Work Order ID 102784

Item Name: Crosstube Turning Detail

DART AEROSPACE LTD	Work Order:	102784
Description: Crosstube Assembly (412 High Aft)	Part Number:	D412-664-243
Inspection Dwg: D412-664-243 Rev: E		Page 1 of 2

DRAWING NO. D412-664-243	TITLE CROSSTUBE ASS'Y (412 HI AFT)	REV. E	DART AEROSPACE LTD ENGINEERING ORDER		D.E.O. NO. D412-664-243-E-2	SHEET NO. SHEET 1 OF 1	SCALE NTS
DRAWN 92	CHECKED AS	MFG. APPR. E	APPROVED MP		DE APPR. H		
DATE 11.09.07	DATE 11.09.19	DATE 11.09.19	DATE 11.09.19		DATE 11.09.19

**D412-664-243
ASSEMBLY DETAIL**

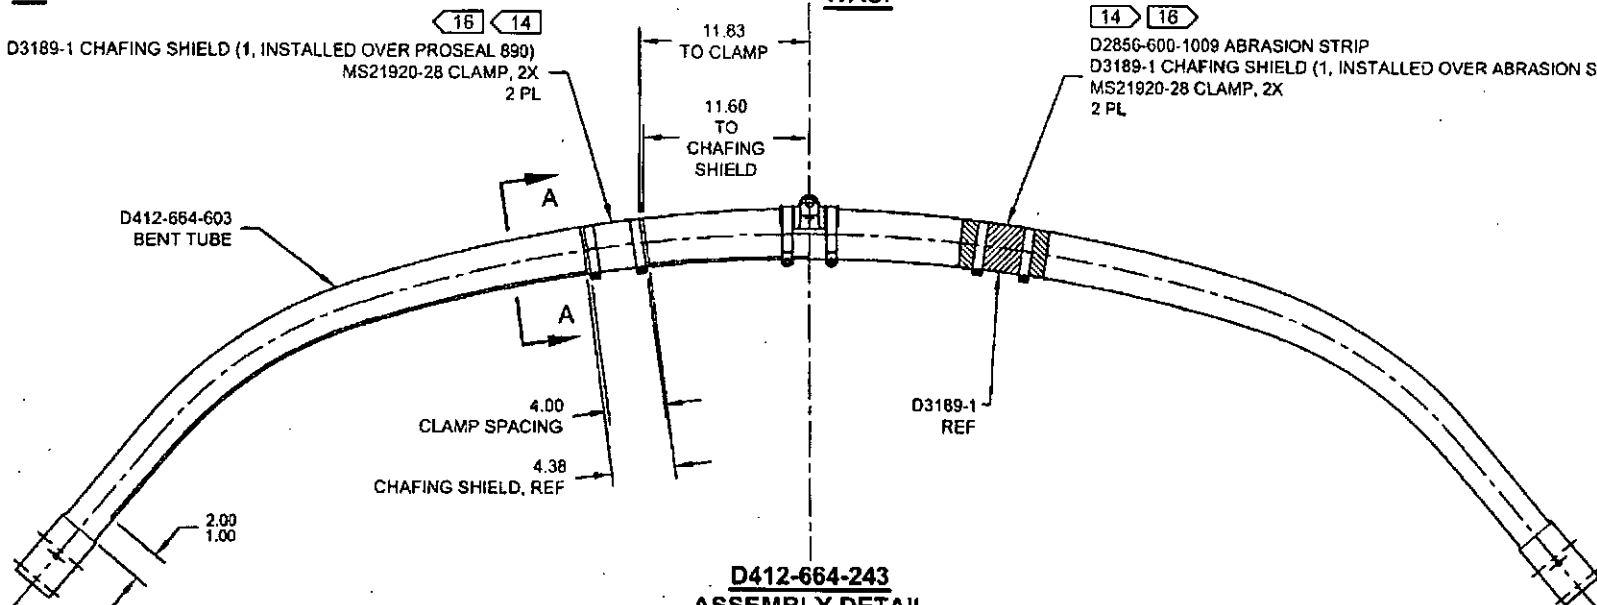
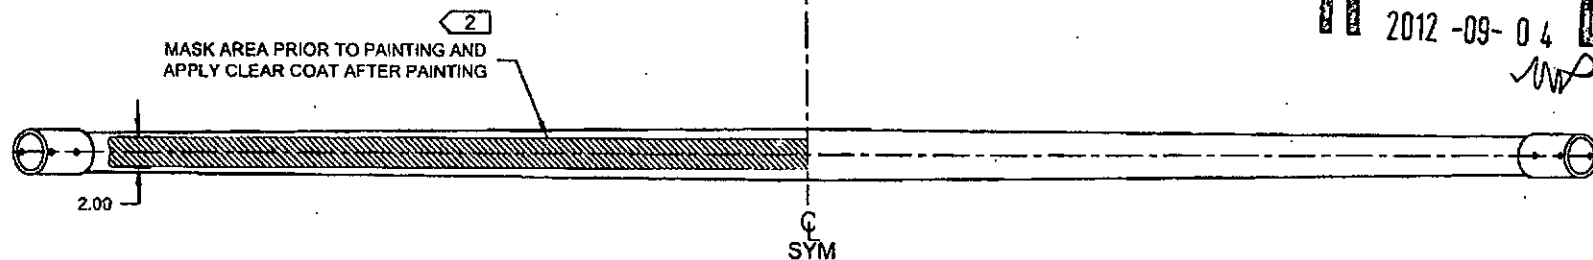
REMOVED ABRASION STRIP IN FAVOR OF A THIN LAYER OF PROSEAL 890. UPDATE INSTALLATION OF CHAFING SHIELDS AND REDUCE TORQUE TO 40-50 IN-LBS. THIS ENGINEERING ORDER SUPERCEDES DEO D412-664-243-E-1.

IS:

D3189-1 CHAFING SHIELD (1, INSTALLED OVER PROSEAL 890)
MS21920-28 CLAMP, 2X
2 PL

WAS:

D2856-600-1009 ABRASION STRIP
D3189-1 CHAFING SHIELD (1, INSTALLED OVER ABRASION STRIP)
MS21920-28 CLAMP, 2X
2 PL

SECTION A-A
CHAFING SHIELD DETAIL
VIEW ROTATED, NOT TO SCALE

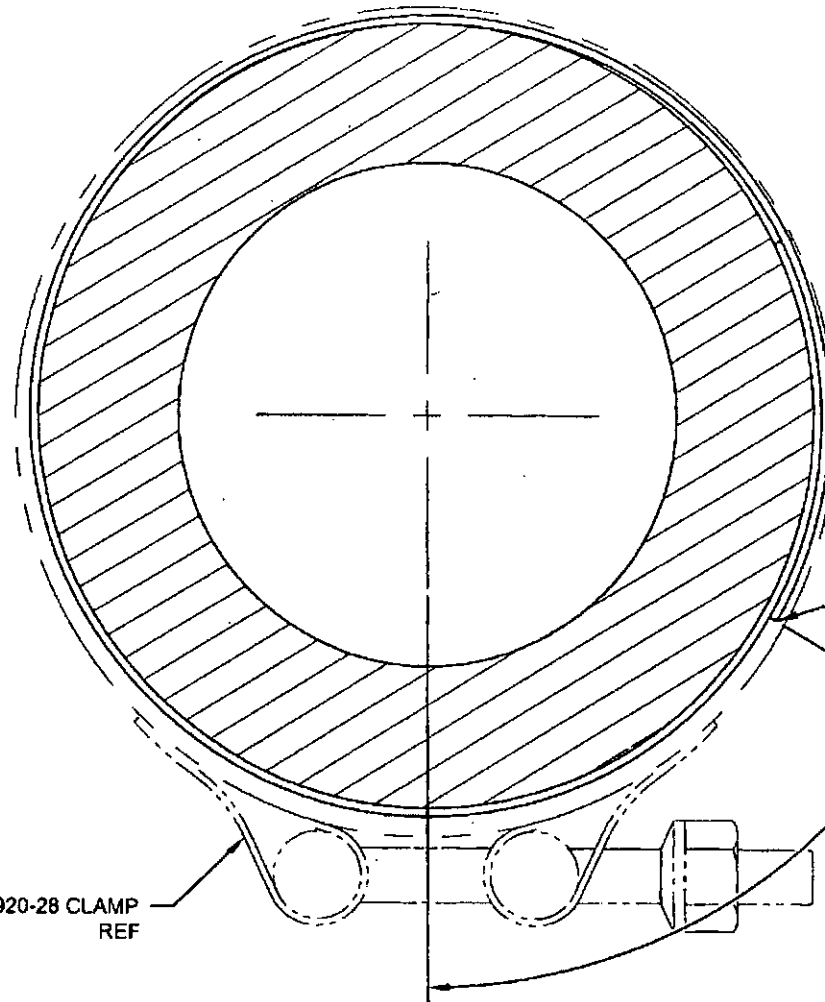
WRAP D3189-1 AROUND
TUBE AND ORIENT
OVERLAP AS SHOWN

70°
50°
